Applicant's Name: Hoaani Merritt & Paige Olsen	Date: 10/06/2021 Start time: 10.30	Date: 7 Oct 2021 Re-Inspection Start time: 1030
Property Address: 37 Symond Road (Off Braemar Rd Onepū end)	Inspection Number: 1	Phone: 0274 595 865 (07)3084584 Email: hoaani.merritt@outlook.co.nz
ITEMS TO BE CHECKED		TAKE PHOTOS
Key: Decision: ✓ or P = Pass X or F = Fail, further inspection required I or — or NA = Not Applicable Reason for decision: Compliance or non-compliance with the approved building consent documents		
ALL POOLS	1 st	2 nd
FENCING		
Fencing (incl. walls) continuous around pool	P	
Fence at least 1200 mm high above ground	P	
Mesh or trellis fence with gaps larger than 10mm (But less than 50mm) to be at least 1.8 metres high	NA	
Horizontal rails on outside of the fence (if any) >900 mm apart	NA	
No climbable objects within 1200 mm of the outside of the fence	P	
No gaps > 100 mm in fence (or >50 mm if mesh/trellis)(Includes Cat/Dog doors in windows/walls of building)	P

Inspection End time:		Re-Inspection End time: 1045	
Work complies with the F9 Acceptable Solutions document		REPEAT: Work complies with the F9 Acceptable Solutions document	
☐ PASS		☐ PASS	
☒ FAIL. Repeat inspection r

*Figure 1 - 7 Oct 21 - glass access gate not self-closing. **13 Jan 2022 inspection.** Still not self closing/latching. Owner advised to remediate so it does or alternatively lock it when not under direct adult supervision.*

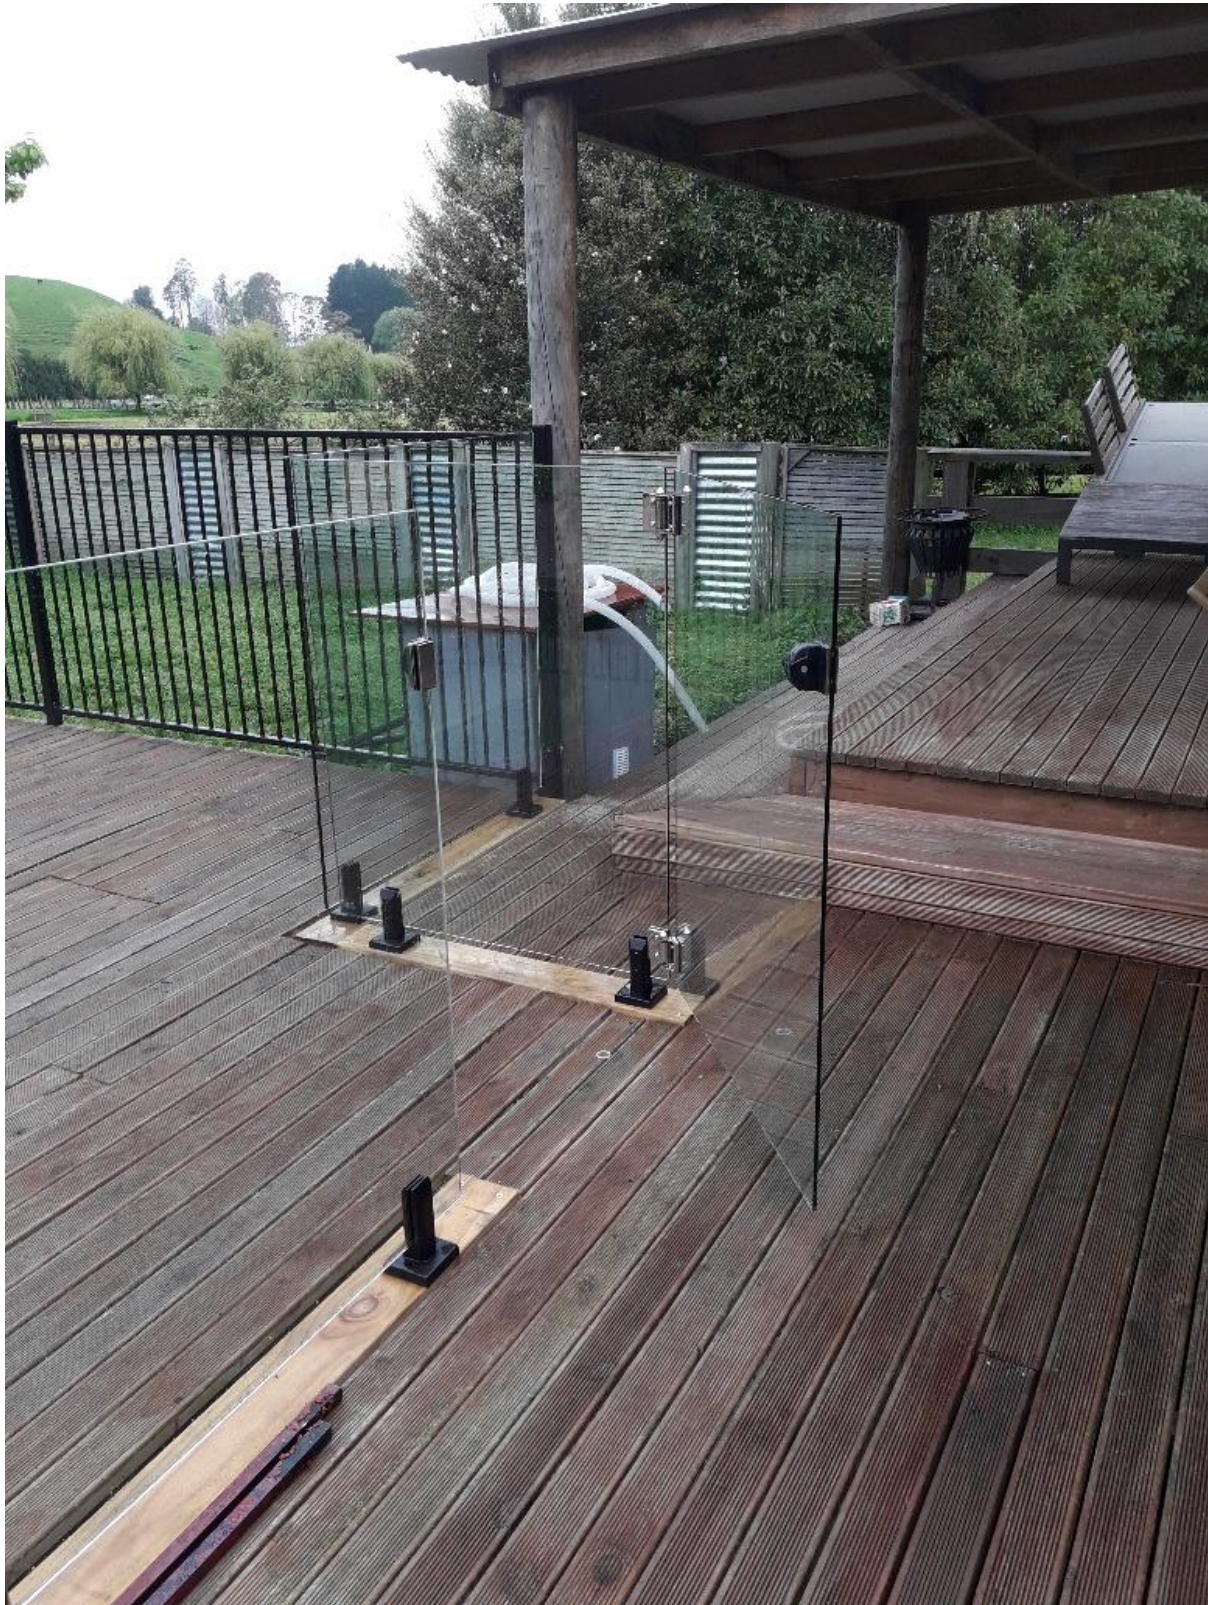
On arrival 2 x internal latching systems are in place on both North & south elevation glass gates which is the issue. The south gate now complies (self-closing/latching from 150mm min), the north one does NOT.

Action item 1: A remediation solution was discussed to lift the gate so it does self-close or alternatively, the gate is to be locked shut on every occasion except when **under direct adult supervision**.
